MJ11/MM11

TECHNICAL
INFORMATION
DEC CONFIDENTIAL

EP-MJ11-00-TI-A

JAN 1977

MM115 REWORK SHEET

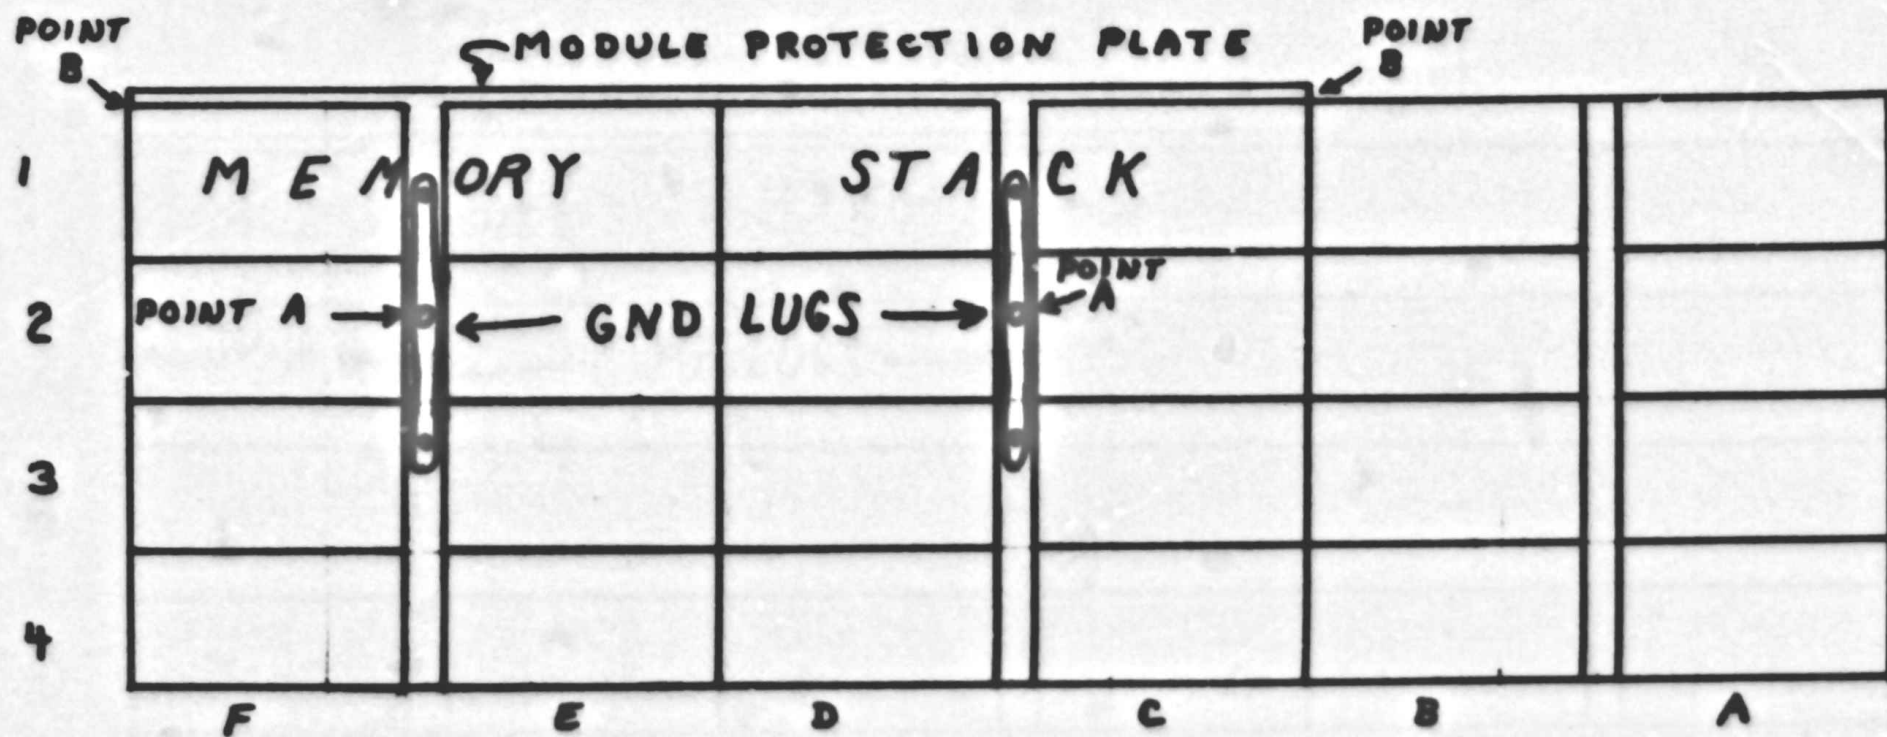
NOTES This FCO is required when other options such as KW11-P, etc. are physically mounted next to an MM11-S memory. Noise generated by the MM11-S may interact with adjacent modules.

ITEM NO.	DOCUMENT/PART NO.	OLD REV	NEW REV	DISP CODE	DESCRIPTION OF CHANGE	DOCUMENTATION AFFECTED	FIELD SERVICE AFFECTED	TYPE OF CHANGE
1.	B-DD-MM11-S	A	B	06	(Drawing Directory) Change per this ECO. (Module Protection Plate) Add D-MD-7408490-0-0 to drawing directory.	<input type="checkbox"/> MODEL <input type="checkbox"/> DIAGNOSTICS <input type="checkbox"/> TECH MANUAL <input type="checkbox"/> TESTER <input type="checkbox"/> TEST PROG <input type="checkbox"/> TOOLING <input type="checkbox"/> PKG INST <input type="checkbox"/> ENG SPEC <input type="checkbox"/> PURCH SPEC	<input checked="" type="checkbox"/> YES <input type="checkbox"/> NO <input type="checkbox"/> Customer Charge <input checked="" type="checkbox"/> Product Line Charge	<input type="checkbox"/> ELECTRICAL <input checked="" type="checkbox"/> MECHANICAL <input type="checkbox"/> MODULE ORDER PR MODEL <input type="checkbox"/> YES <input checked="" type="checkbox"/> NO
